ARCHITECT'S SUPPLEMENTAL INSTRUCTIONS

PROJECT:	The Reserves at South Lake New Apartment Complex Grinnell, IA	Report No.	One (1)
OWNER:	OPG South Lake Partners, LLC Dan Maximuk 234 N. Santa Fe Ave, Suite A Salina, KS 67401	Date	Nov. 14, 2022
CONTRACTOR:	MCP Group 3501 SW Fairlawn Rd. Topeka, KS 66614	Architect's Proj No.	20-3118
		Contract For:	General Construction Mechanical, Electrical

VE Items

A3.1

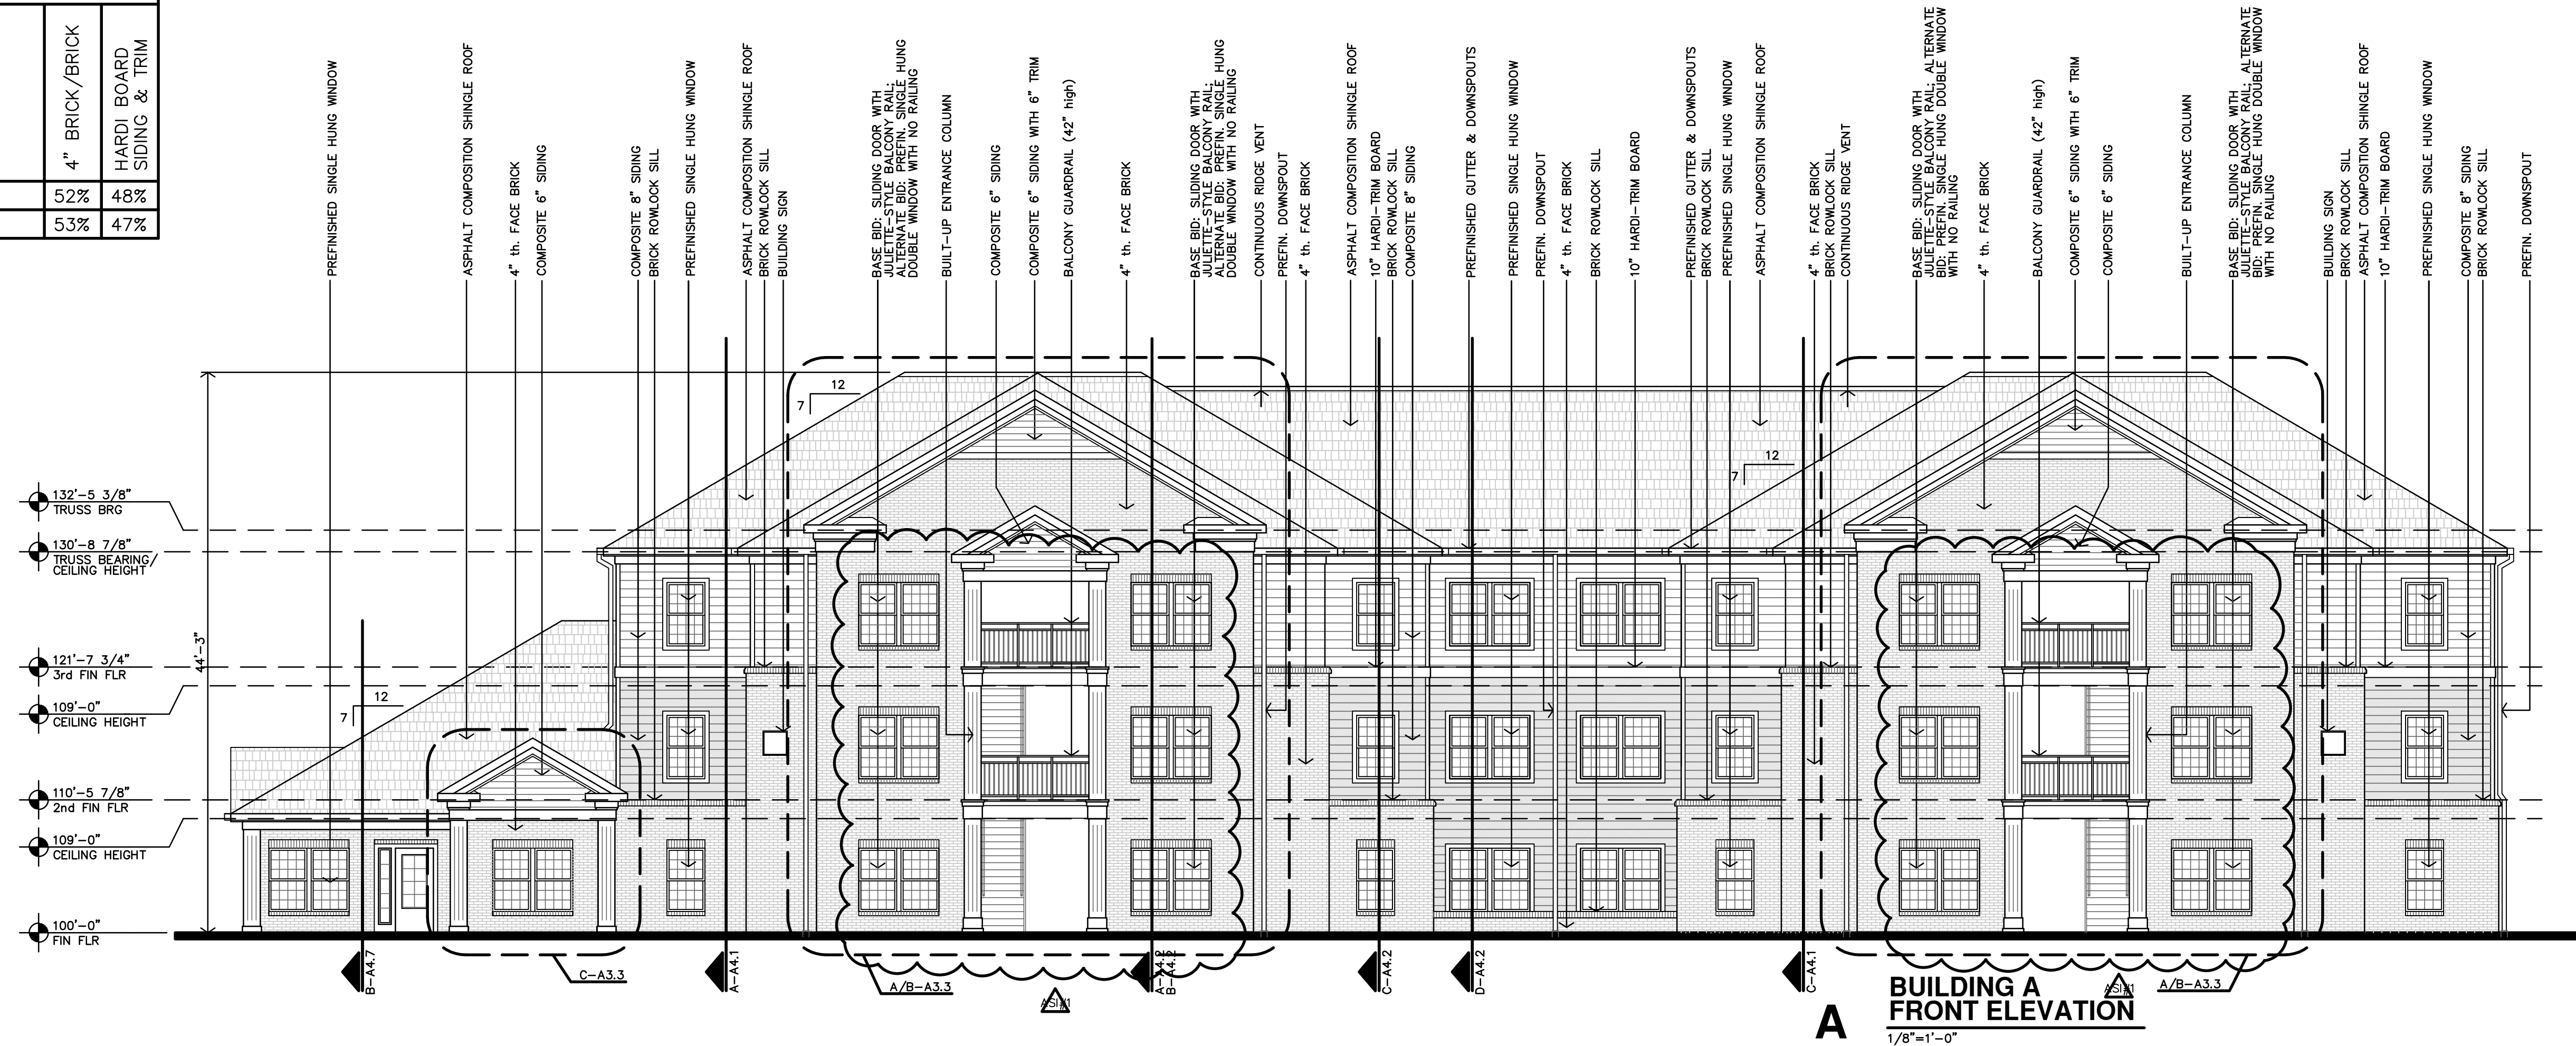
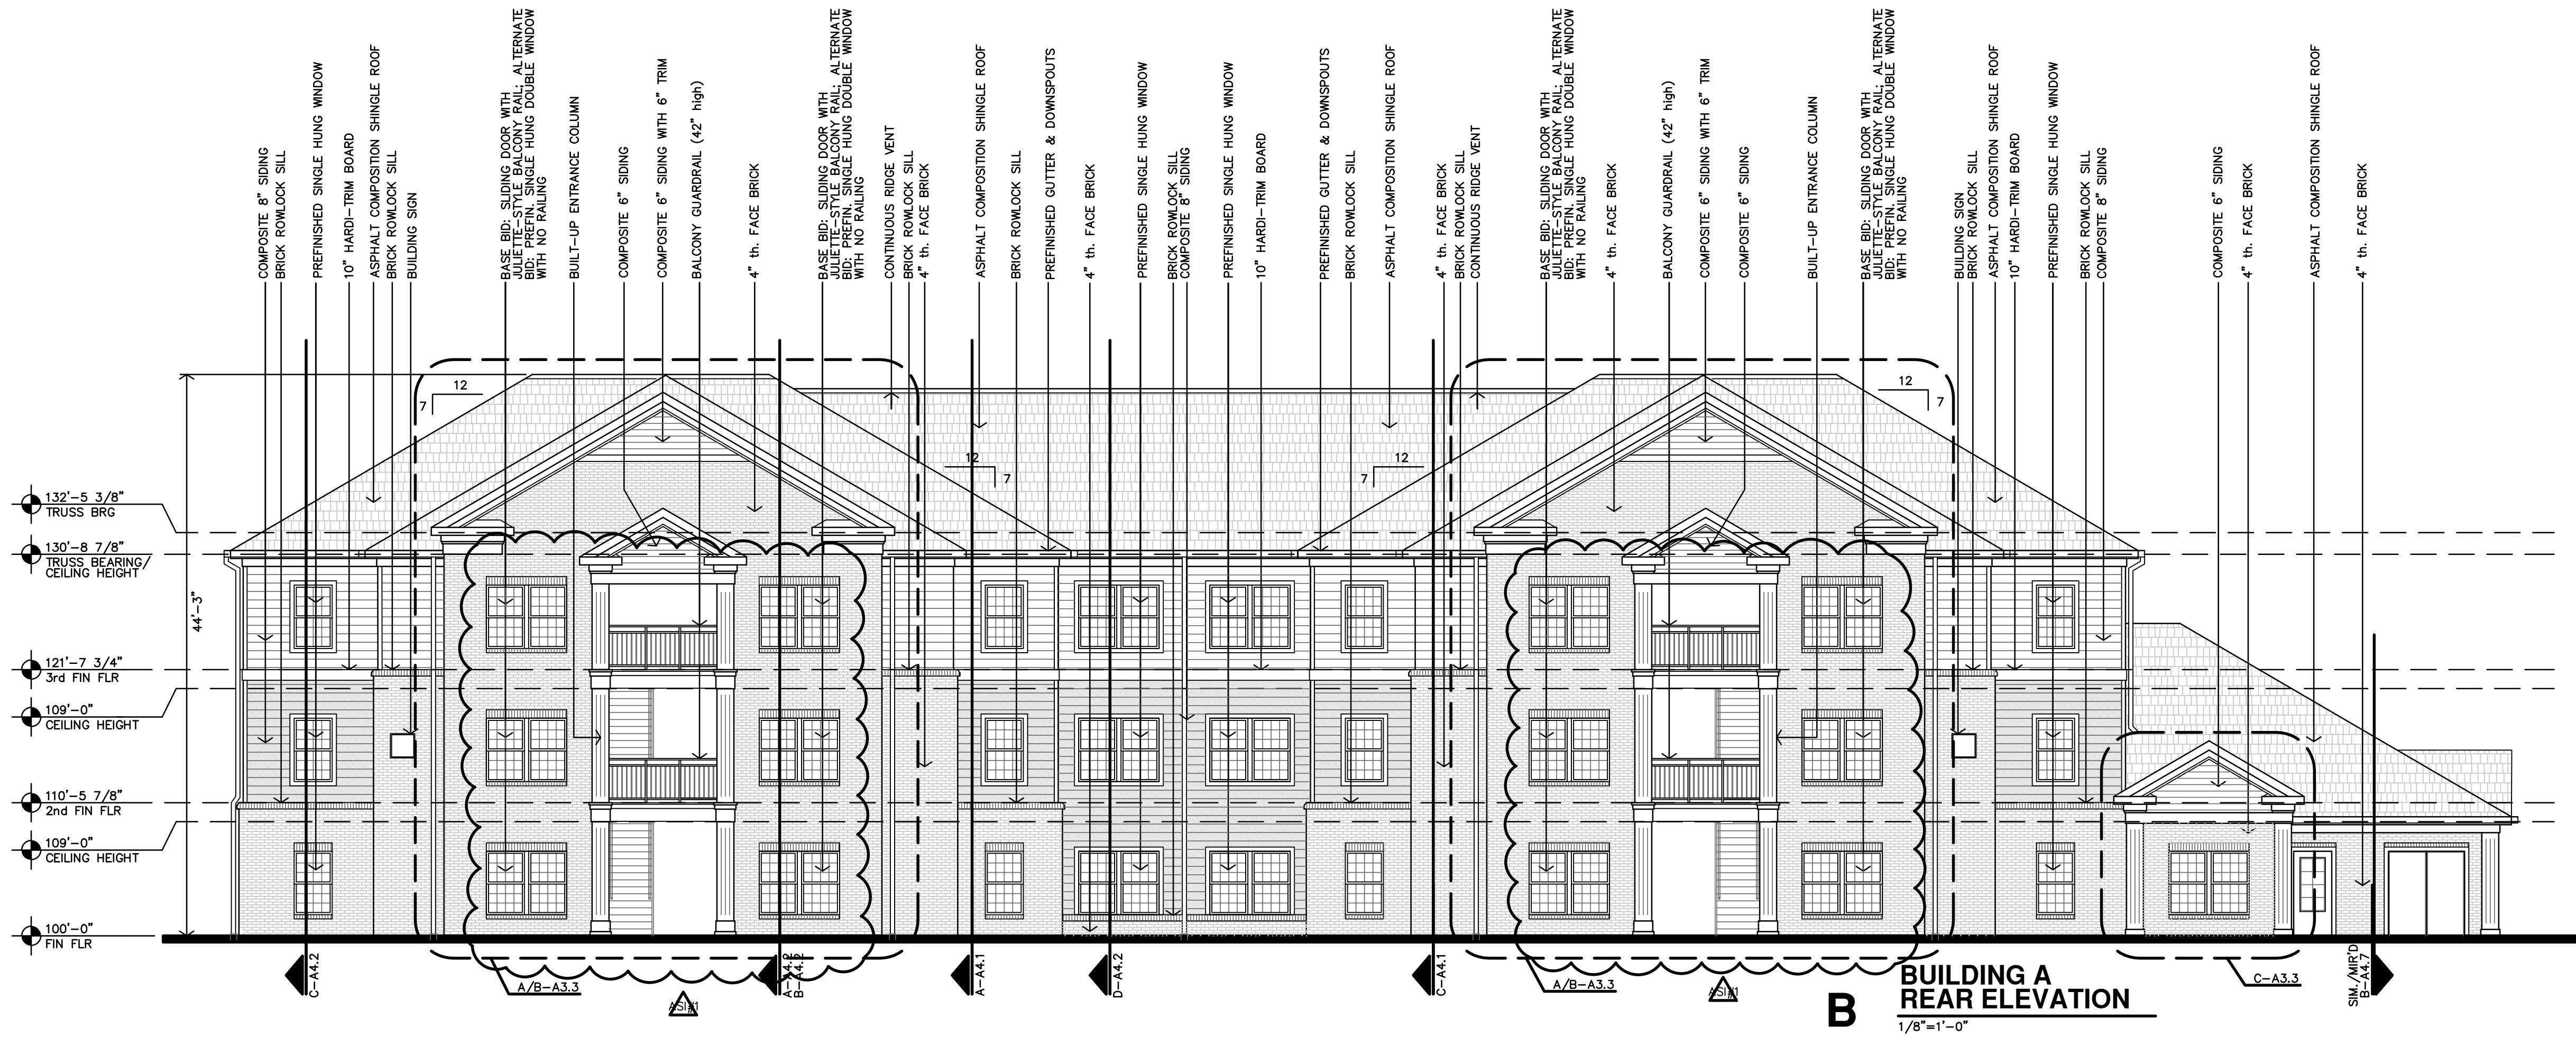
- a. Approx. 1,372sf brick veneer removed. Ref. sheet A3.1 & A3.2
- 5) Delete patio doors & Juliet rails
 - a. Alternate #3 selected.
- 6) All electric
 - a. Alternate #4 selected, Issued per Addendum #2 & #3
